USR2 Ethernet			
TITLE	\$Date\$		
FILE: ethernet.sch	REVISION:	\$Revision\$	
PAGE 6 OF 8	DRAWN BY:	\$Author\$

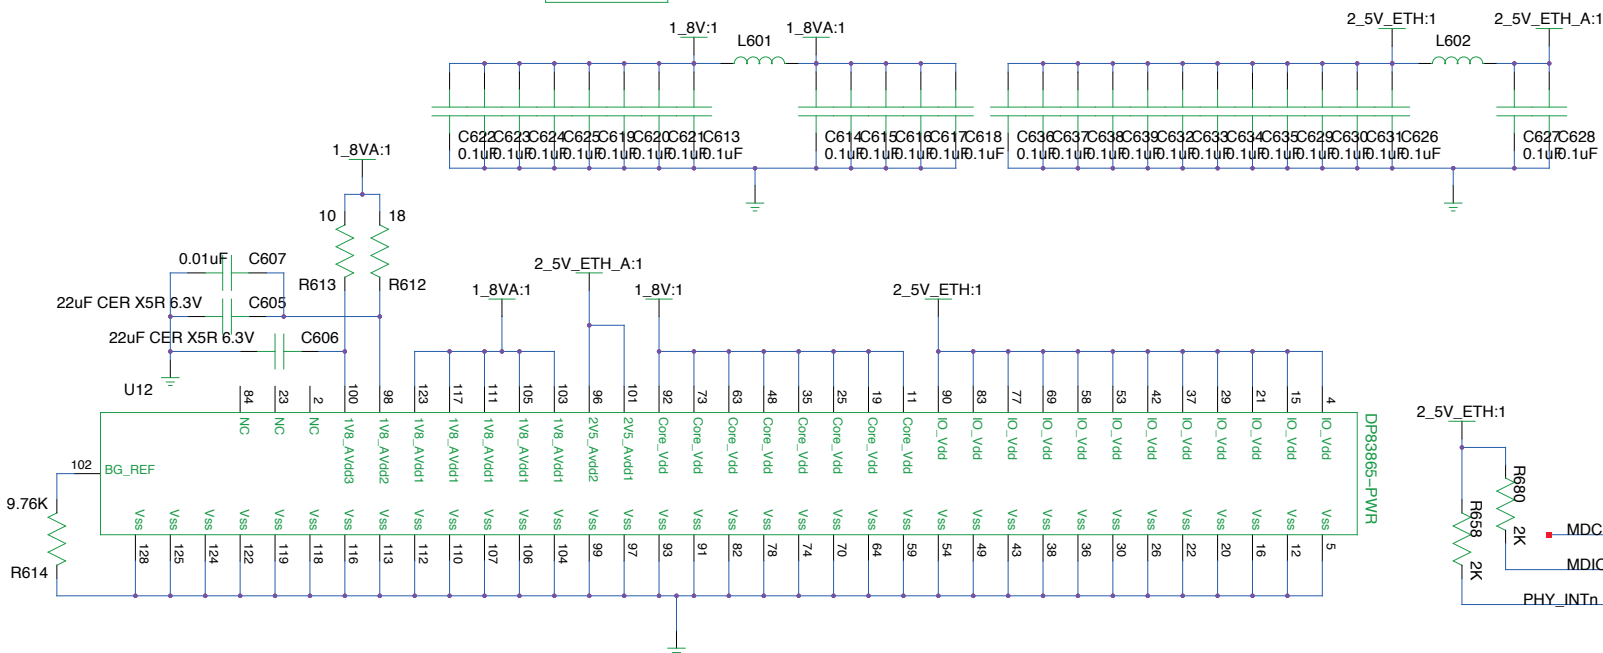
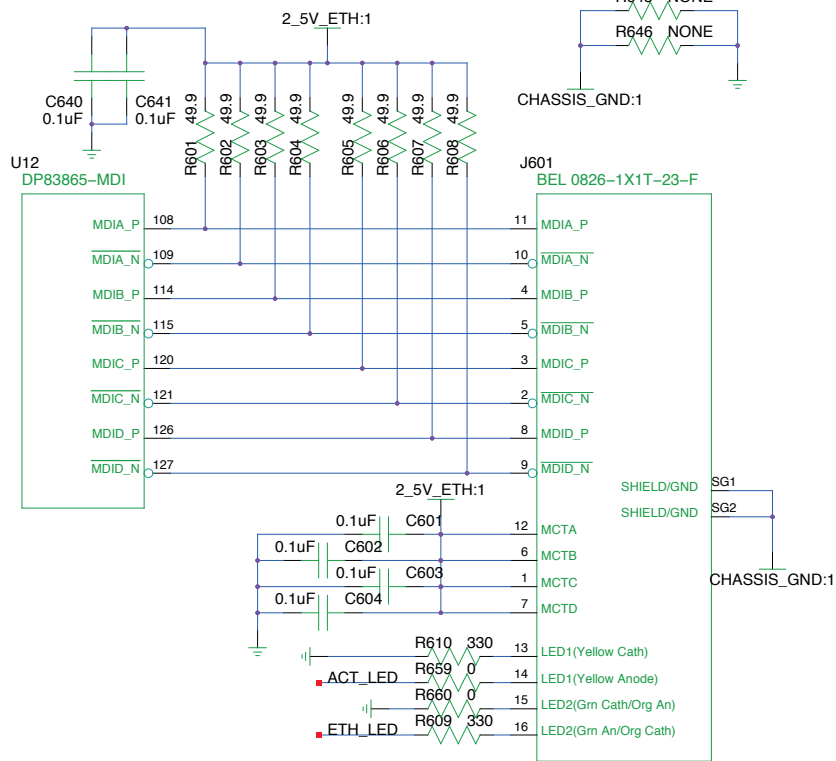
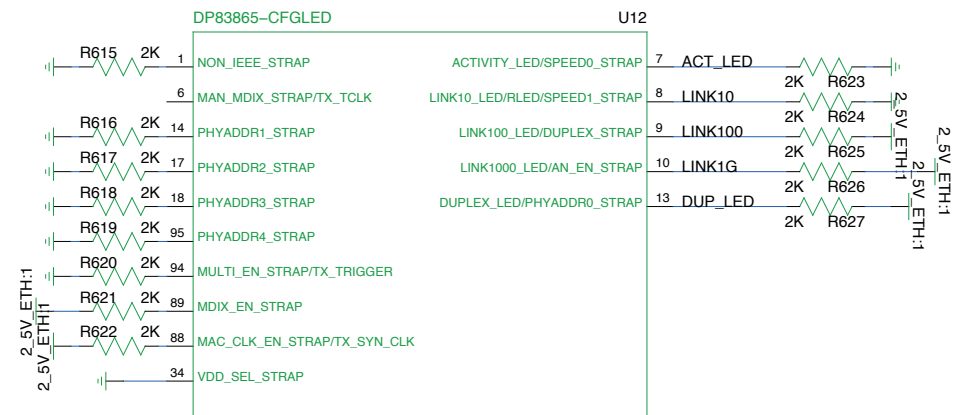
Add caps at 2.5V near PHY

LED Polarities!!!
Section 5.9

Everything on 2.5V
